TECH-HINT

Complete blank transport bar – X3 type

MACHINE TYPE: X2 REFERENCE CODE: X2.146 – X2.146A

Complete blank transport bar – X3 type

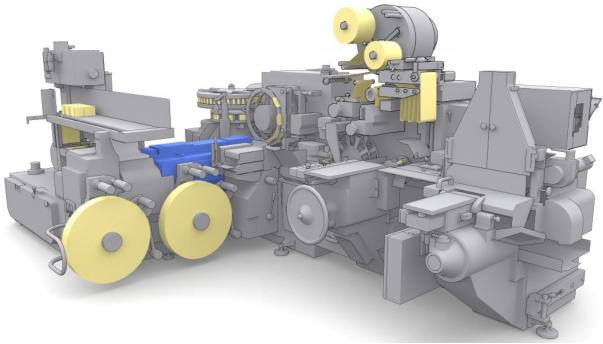
The upgrade kit features the installation of the complete blank transport bar with positive belt on the X2 packer in order to reduce maintenance time and wastes.

Compared with the X3 solution, the traditional blank transport bar of the X2 requires longer maintenance time because of the presence of the transport rollers. The roller wear can lead to jams due to blank out of position at the end of the acceleration group.

The positive belt over the blank, along with a lower metallic guide, ensures precise blank handling throughout all the transport and gluing phases.

The kit also includes a new code embossing group, placed downstream of the gluer in order to maintain the centered print. The gluer has now 4 slopes and ensures a better gluing in case of special packets, eliminating the dust-flap phenomena. Moreover the gluer is cooled thus keeping constant the glue chemical characteristics.
